February 12, 2025

Town of Parker
Public Works Department
20120 E. Mainstreet
Parker, Colorado 80138

**Subject: Horse Creek Commercial
Lot 10B, Douglas 234 Filing No. 6, Amendment 2
Drainage Conformance Letter**

**FIGURE 5.1
RAINFALL INTENSITY VERSUS DURATION CURVES FOR PARKER, COLORADO**

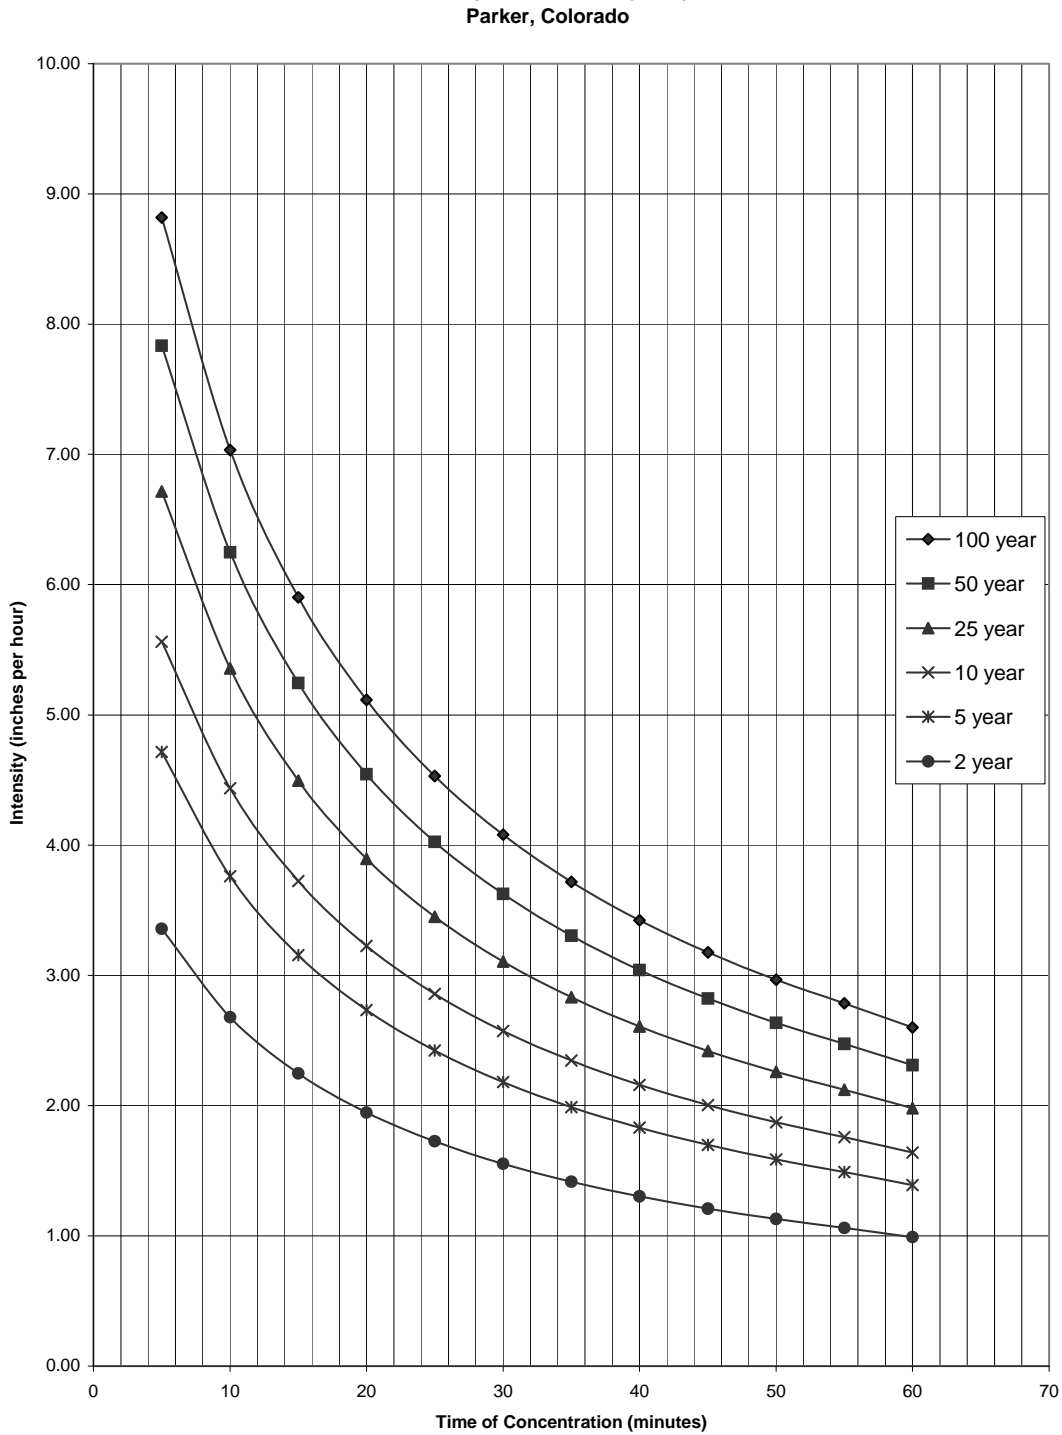
Please use latest NOAA Atlas 14 point rainfall values for Town of Parker in Hydrology calculations and provide reference to the data used in this report. Parker is in the process of updating the SDECM to reflect this in requirement.

INLET IN A SUMP OR SAG LOCATION

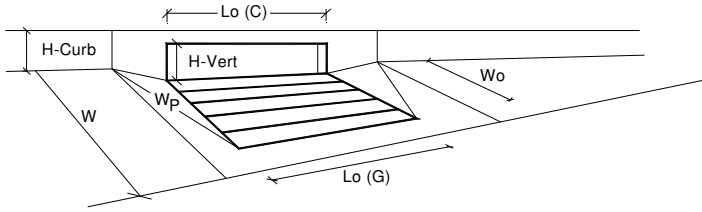
Please include the Initial Sheet for inlet capacity/spread calcs showing assigned flows for the minor and major storm events and bypass flows.
